Access Compliance Report

Public Rights-of-Way

(Curb Ramps)

Intersection ID: 14442	Main Street: N_SHARON_AMITY_RD	Cross Street: CENTRAL_AV	Location: NE
ADA ID: E074C96AD2D0	Ramp Type: Perp	Initial Pass/Fail: Fail	Overall Compliance: No
Severity Score: 12.5			
Codes/Mitigation Info/Possible Solution		Field Measurements/Component Compliance

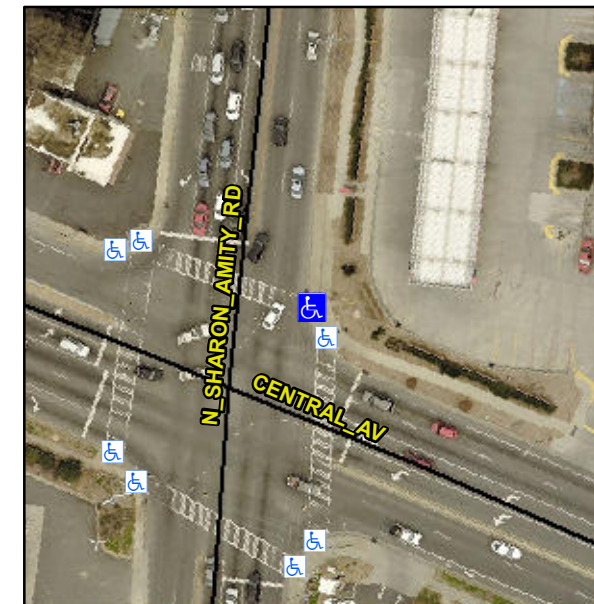
Not Found, R304.2.2

Compliance	Description	Data	Compliance	Description	Data
N/A	Ramp Length (in)	60.5	No	Ramp Slope (%)	8.6
Yes	Ramp Width (in)	48.0	Yes	Ramp XSlope (%)	0.4
N/A	Flare Type LT	N/A	N/A	Flare Type RT	N/A
N/A	Flare Slope LT (%)	N/A	N/A	Flare Slope RT (%)	N/A
N/A	Flare Traversable LT?	N/A	N/A	Flare Traversable RT?	N/A
N/A	Landing Length (in)	N/A	N/A	DWS Provided?	N/A
N/A	Landing Width (in)	N/A	N/A	DWS Contrast?	N/A
N/A	Landing Slope (%)	N/A	N/A	DWS Length (in)	N/A
N/A	Landing X Slope (%)	N/A	N/A	DWS Full Width?	N/A
N/A	Landing Curb? (Y/N)	N/A	N/A	DWS Offset (in)	N/A
N/A	Shared Landing?	N/A			
N/A	Gutter Ponding?	N/A	N/A	Gutter Slope (%)	N/A
N/A	Gutter Lip Ht (in)	N/A	N/A	Gutter X Slope (%)	N/A
N/A	Painted X Walk1?	Yes	N/A	Painted X Walk2?	N/A
	X Walk 1 Direction	To NW		X Walk 2 Direction	N/A
N/A	X Walk 1 Width (in)	112.0	N/A	X Walk 2 Width (in)	N/A
	X Walk 1 Slope (%)	2.6		X Walk 2 Slope (%)	N/A
	X Walk 1 X Slope (%)	0.9		X Walk 2 X Slope (%)	N/A

Remove & Replace Entire Ramp.
